# SECOND AMENDMENT TO THE APPLICATION TO THE OHIO POWER SITING BOARD FOR A CERTIFICATE OF ENVIRONMENTAL COMPATIBILITY AND PUBLIC NEED

OPSB CASE NO. 20-0145-EL-BTA

## Amendment to Buckley Road-Fremont Center 138 kV Transmission Line Project #2

**American Electric Power Ohio Transmission Company**

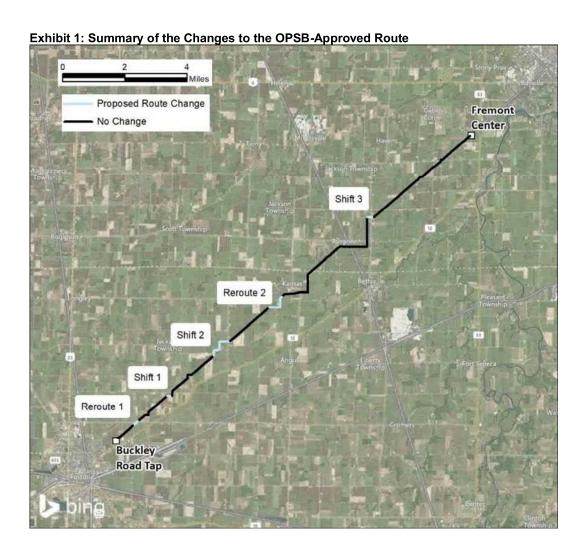
Table 1							
Second Amendment Structure Shifts							
Structure	Distance from OPSB-Approved Centerline (feet)						
31	37						
32	41						
57	67						
58	61						
59	9						
60	11						
61	14						
62	33						
63	29						
64	27						
65	85						
66	78						
67	71						
68	63						
151	23						
152	28						
153	32

#### **Exhibit 2: Reroute 1**

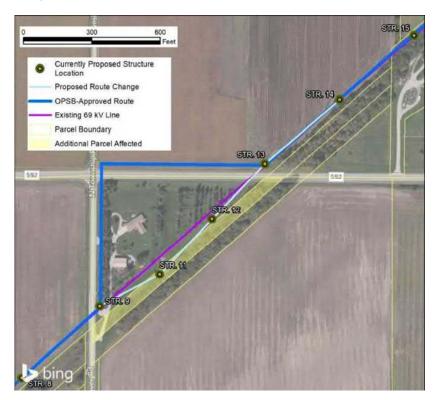
Reroute 1 is approximately 0.3 mile long and occurs between Structures 9 and 14. This reroute makes use of the existing 69kV line corridor and removes Structure 10 from the alignment. An Easement Option is being coordinated with the landowner. This reroute avoids the clearing manicured trees, avoids the road ROW along North Township Road 45 and CR 592, removes a 90-degree turn, and optimizes structure alignment while utilizing the existing transmission line ROW. The tree line impacted by the OPSB-approved route currently provides a residential structure screening from North Township Road. A parcel that is currently impacted by the existing corridor is additionally impacted by this reroute, though there are no newly affected landowners. There are no additional environmental impacts. The reroute reduces tree clearing from 0.6 acre, which includes frontage trees on a residential property for the OPSB-Approved Route, to 0.3 acre along the proposed Reroute 1.

#### Exhibit 3: Reroute 2

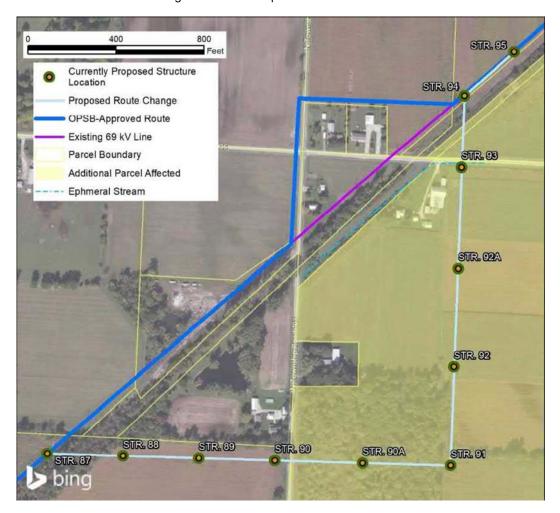
Reroute 2 is approximately 0.7 mile long and occurs between Structures 87 and 95. This reroute was developed in coordination with the property owners within the area. The reroute is necessary to minimize visual impacts to residences and impacts to surrounding farm fields. The reroute creates a greater distance between the proposed line and residential properties and allows the Company to construct behind a tree-line buffer in certain locations. To minimize potential impacts to farm fields and farming operations, structures will be placed on the edge of farm fields. Structures 90A and 92A are new structures necessary to ensure ground clearances between structures 90-91, and 92-93. Three new parcels and two additional property owners are affected by the alignment change. Easement Options are being coordinated with the property owners affected. Between Structures 87-88 and 90-91, approximately 2.38 acres of tree clearing is required as compared to 0.54 acre of clearing on the OPSB-Approved Route. The proposed route change crosses one ephemeral stream, an unnamed tributary to Wolf Creek, which is mapped to the north of Structure 93 alongside W. Township Road 36.

#### **Exhibit 4: Engineering Adjustment 1**

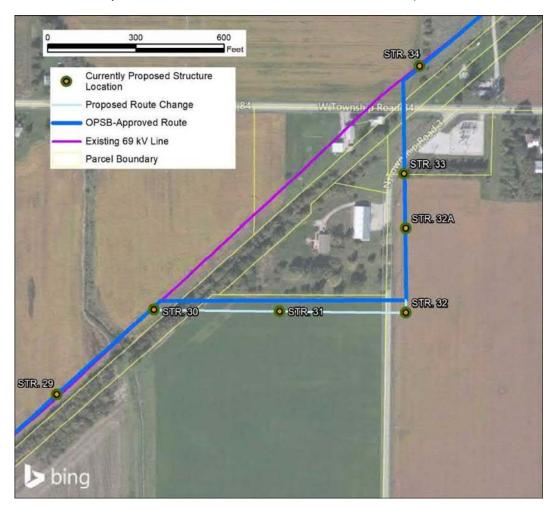
Engineering Adjustment 1 is approximately 0.2 mile long and occurs between Structures 30 and 33. Structure 32A is being added along the centerline to lessen the span length between structures 32 and 33. The smaller span lengths are necessary to reduce the height of Structures 33 and 34 to comply with FAA clearance requirements for a nearby airport. Structure 32A was not a proposed structure on the OPSB-Approved route, and, therefore, was not included in Table 1. Structures 31 and 32 shifted 37 feet and 41 feet respectively to avoid an overhang easement and corresponding tree clearing on the adjacent residential property. This adjustment reduces impacts to residential properties by placing the structures on the edge of farm fields. There are no additional property owners affected by this shift, and there are no additional environmental impacts.

#### **Exhibit 5: Engineering Adjustment 2**

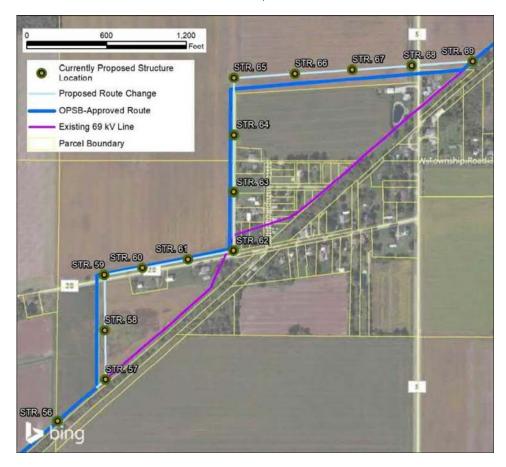
Engineering Adjustment 2 is approximately 0.9 mile long and occurs between Structures 57 and 69. The structure shifts range from 9 feet at Structure 59 to 85 feet at Structure 65. These shifts were necessary to reduce impacts to farming operations and to avoid a pipeline and existing distribution-line ROW. The Company shifted Structures 57-59 at the request of the landowner; there are no additional impacts anticipated as a result of these shifts. Additionally, after coordinating with the landowner, the Company shifted Structures 59-64 to position the structures along the landowner's property boundary. The Company shifted Structures 60-62 to provide a greater clearance to an existing distribution line. Structures 65-68 shifted north to allow operation of farming equipment between the structure locations and the property line. Easement Options have been secured for this adjustment. There are no additional property owners affected by this shift, and there are no additional environmental impacts.

#### **Exhibit 6: Engineering Adjustment 3**

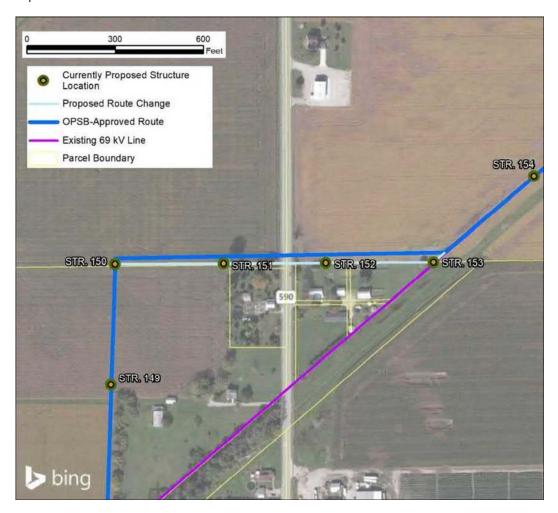
Engineering Adjustment 3 is approximately 0.2 mile long and occurs between Structures 150 and 153. The alignment shift was developed after coordination with the property owner, and is necessary to shift the alignment closer to the edge of the property line. This shift minimizes impacts to farming operations. Easement options have been obtained on the affected parcels. There are no additional property owners affected by this shift, and there are no additional environmental impacts.
